Model: Martini-C2	Date: 14-Oct-04	No.: RB140001d
-------------------	-----------------	----------------

Subject: Firmware Release History (BCU - Engine)		Prepared by: S. Watanabe	
From: 2nd Tech Support Sec. Service Support Dept.			
Classification:	<input type="checkbox"/> Troubleshooting	<input type="checkbox"/> Part information	<input type="checkbox"/> Action required
	<input type="checkbox"/> Mechanical	<input type="checkbox"/> Electrical	<input type="checkbox"/> Service manual revision
	<input type="checkbox"/> Paper path	<input type="checkbox"/> Transmit/receive	<input type="checkbox"/> Retrofit information
	<input checked="" type="checkbox"/> Other (      )

## 2. Page 3-33 (Replacement and Adjustment)

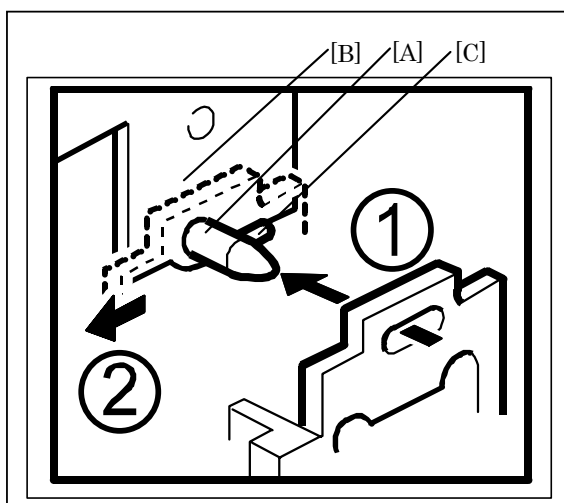
- **Note:** Steps 5-13 of the procedure on pg. 1-11 were not changed.
- **IMPORTANT:** As mentioned below, before you begin the procedure on pg. 1-11, make sure to **remove the toner bottle first**. If the toner bottle is in the machine when you do this procedure, **the toner bottle holder can be damaged**.

## 1. Pg. 1-11 (Installation)

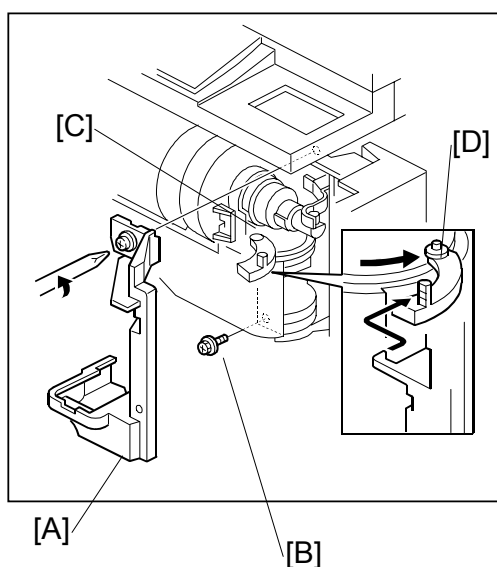
**IMPORTANT:** Before you begin, **remove the toner bottle** if it is installed.

## BCU Board (Base Engine Control Unit)

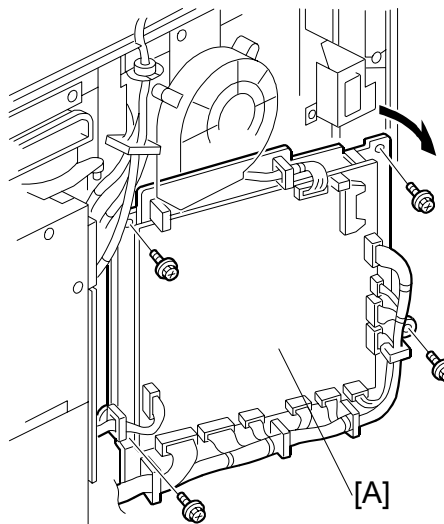
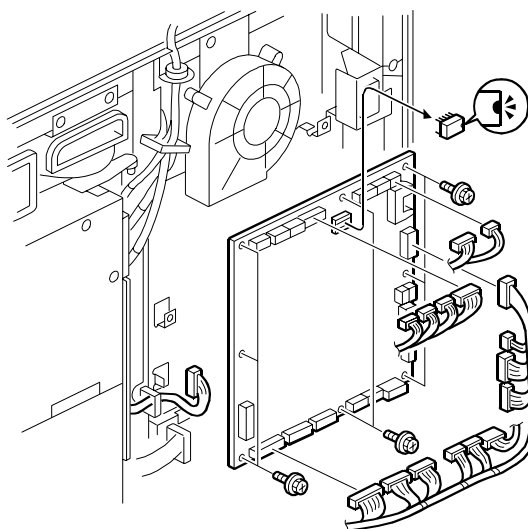
The step in *bold italics* below was added.

4. ***Remove IC31 (EEPROM) from the old BCU board, and then attach it to the new BCU board.***
5. Make sure the DIP Switch settings on the new BCU board are **the same** as the DIP Switch settings on the old BCU board.
6. Attach the new BCU board.
7. Do SP3001-002 (ID Sensor Initialization).

## SYMPTOM

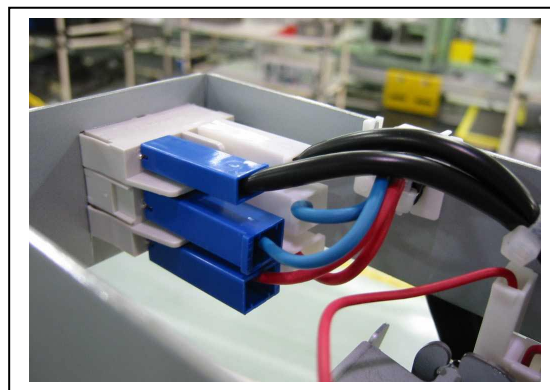
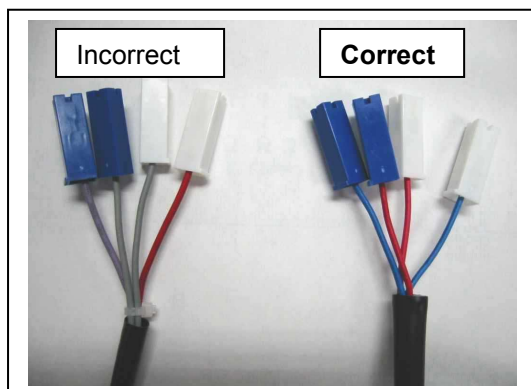
Some cables on the PSU harness are the wrong color.

**For the correct colors, see photo below.**

When you replace the PSU on the machines listed below, attach the connectors according to the color of the **connectors**. Ignore the color of the harness cables.

**Note:** Only the color of the cable covering is incorrect. The internal wiring is correct.

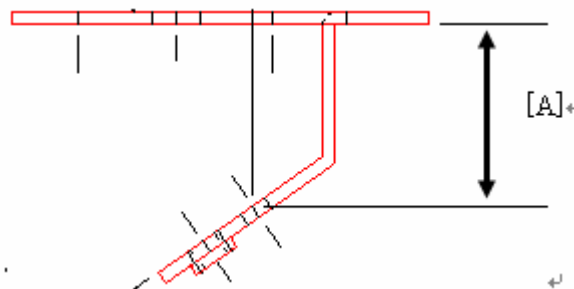
*The distance [A] is different between the new and old brackets .*

**B1404196/7: 14.8mm**

**D0624196/7: 15.3mm**

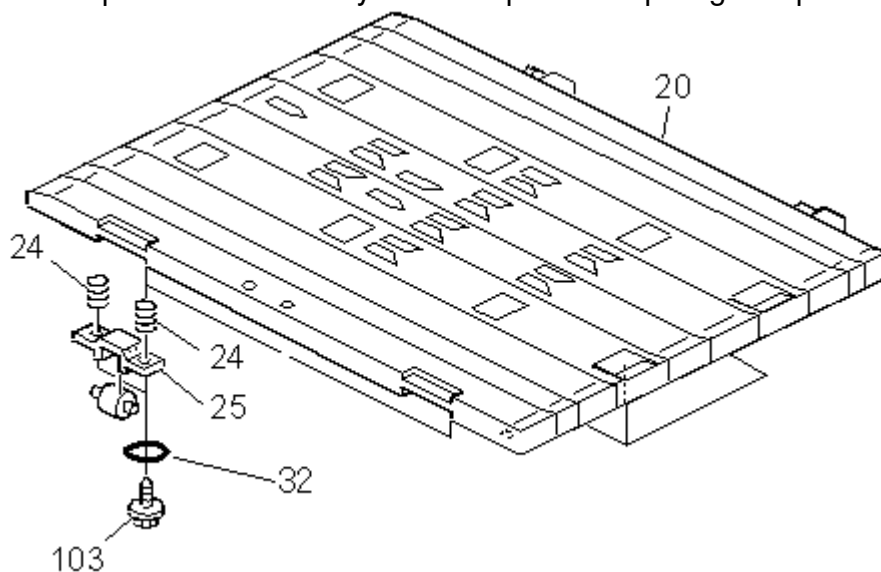
### Change:

1. The thickness of the duplex transport guide plate was increased.
2. The diameter of the spring was increased.
3. A spacer was added.
